Exhibit B - Planning Commission Staff Report

**PLANNING COMMISSION
STAFF REPORT**

Subject: Staff Report (For Possible Action): Case No. LDC25-00003 (2400 West 7th Street): A request has been made for: 1) a tentative map for a 28-lot single-family detached subdivision; and 2) a major site plan review for cluster development. The ±3.72 acre project site is located directly south of the intersection at West 7th Street and Rhode Island Drive. The site is located in the Single-Family Residential – 8 units per acre (SF-8) zoning district and has a Master Plan land use designation of Single Family (SF).

Case No.: LDC25-00003 (2400 West 7th Street)

Figure 2

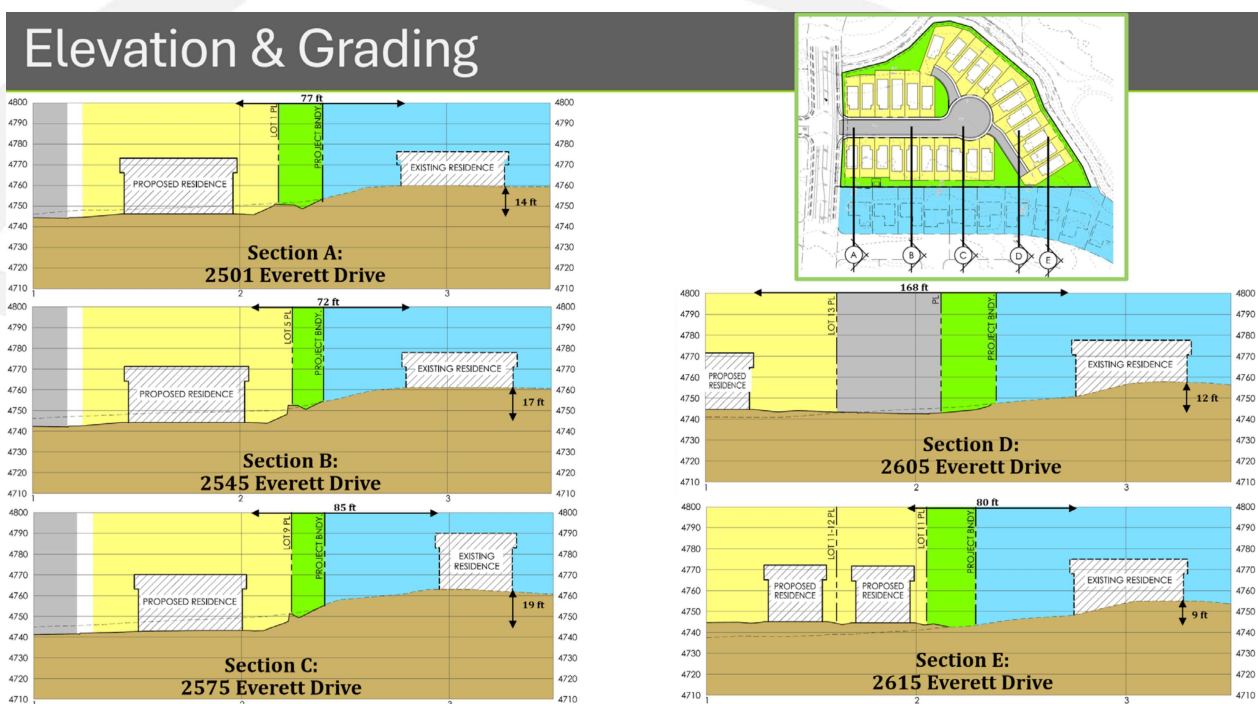
Even if this grade is accurate, (figure 2) homes A, B, D and E would have to stand on their roofs to see over adjacent homes. This is not protecting views.

Wood Rodgers Elevation and Grading 2605 and 2615 Everett Dr

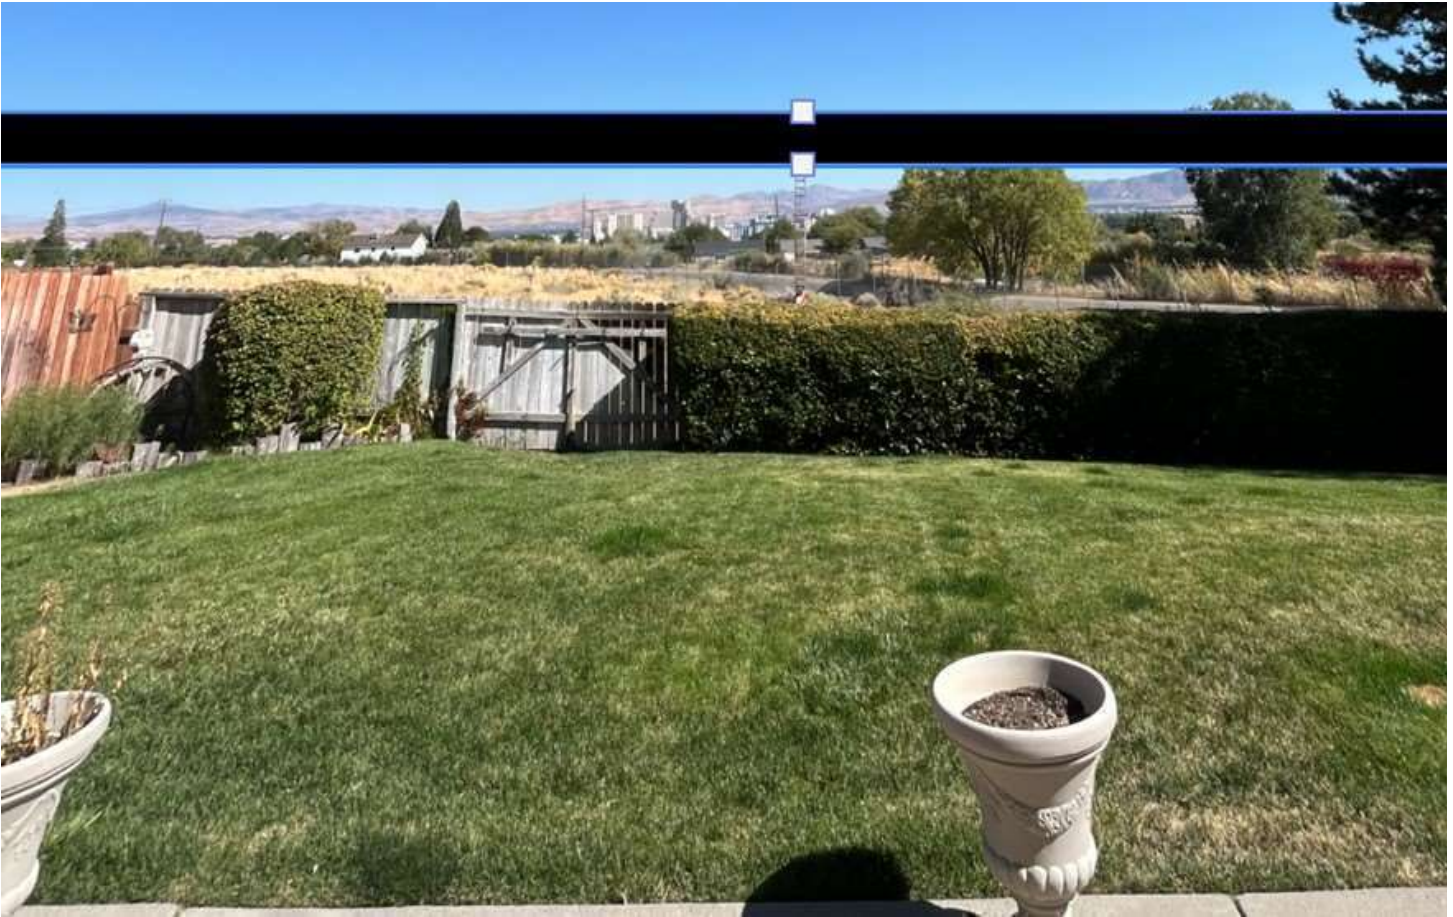
Pictures of where rooflines will approximately fall. Homes on SE boundary do not allow views between houses due to 45 degree offset.

2615 view from back patio to estimated height of home 13 (point E). 28' roofline. From highland ditch grade/base elevation. (Home 11 will be much more obtrusive due to closer proximity.)

2605 Everett view from 2nd story deck to estimated height of home 14. 28' roofline. From highland ditch grade/base elevation.
